SUNDRY NOTICES AND REPORTS ON WELLS

Beginner BLB Federal Com #2H

Yates Petroleum Corporation wishes to extend the captioned well's APD for two (2) years to October 31, 2012.

# PECOS DISTRICT CONDITIONS OF APPROVAL

#### **Cross Section of a Typical Lead-off Ditch**

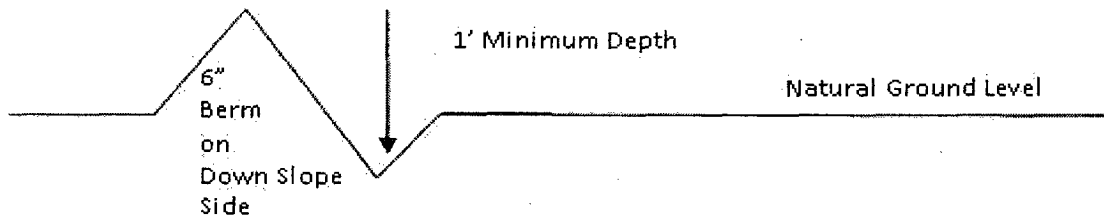
A typical lead-off ditch has a minimum depth of 1 foot below and a berm of 6 inches above natural ground level. The berm shall be on the down-slope side of the lead-off ditch.

All lead-off ditches shall be graded to drain water with a 1 percent minimum to 3 percent maximum ditch slope. The spacing interval are variable for lead-off ditches and shall be determined according to the formula for spacing intervals of lead-off ditches, but may be amended depending upon existing soil types and centerline road slope (in %);

**Figure 1 – Cross Sections and Plans For Typical Road Sections**

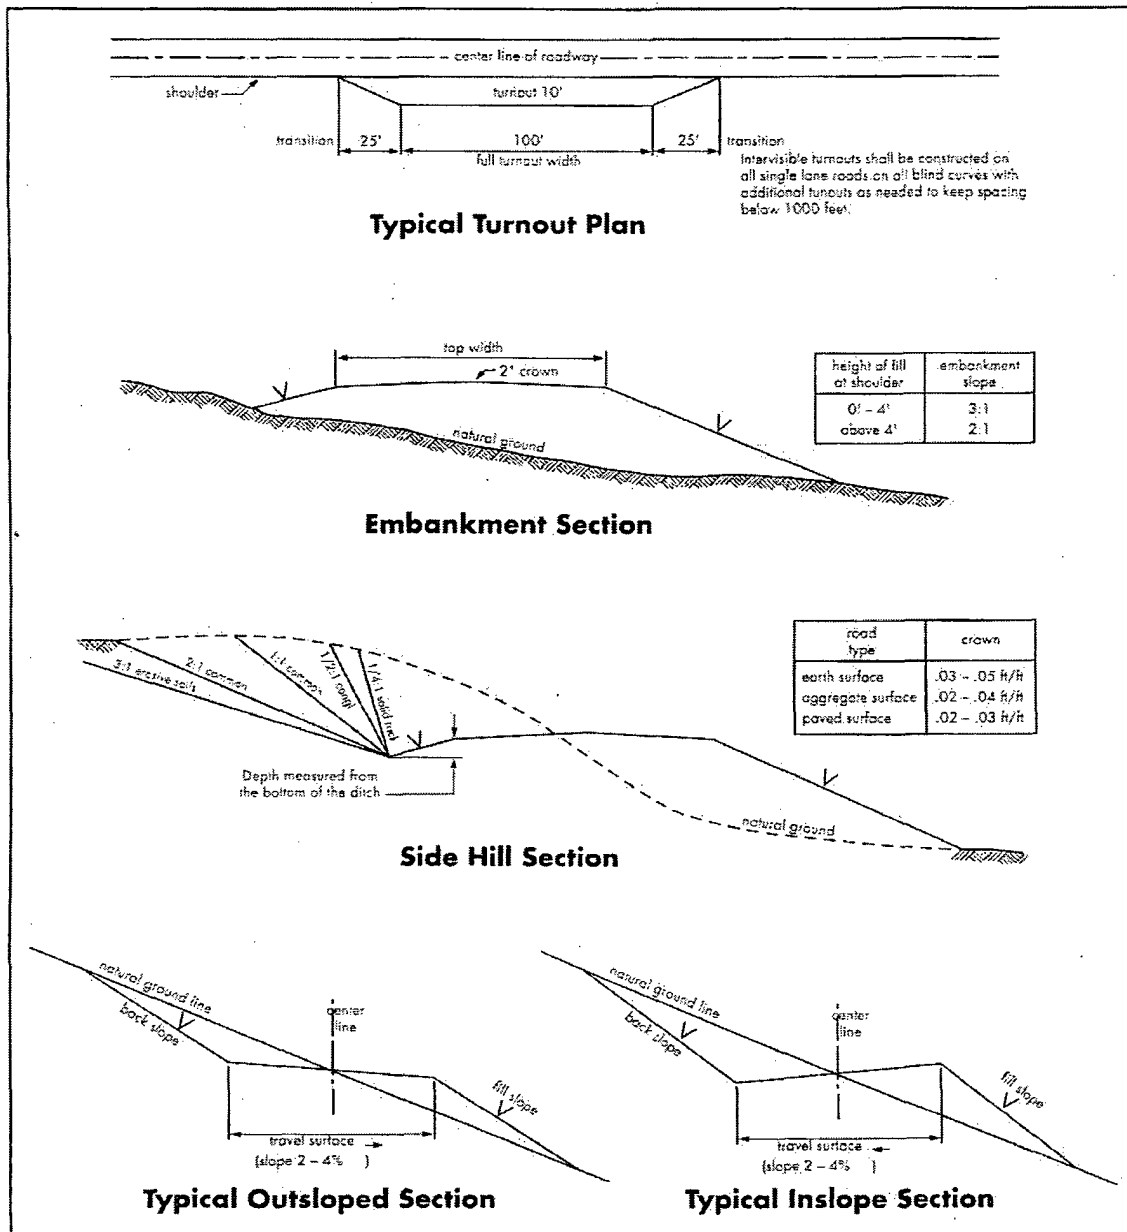
Crowning shall be done on the access road driving surface. The road crown shall have a grade of approximately 2% (i.e., a 1" crown on a 14' wide road). The road shall conform to Figure 1; cross section and plans for typical road construction.
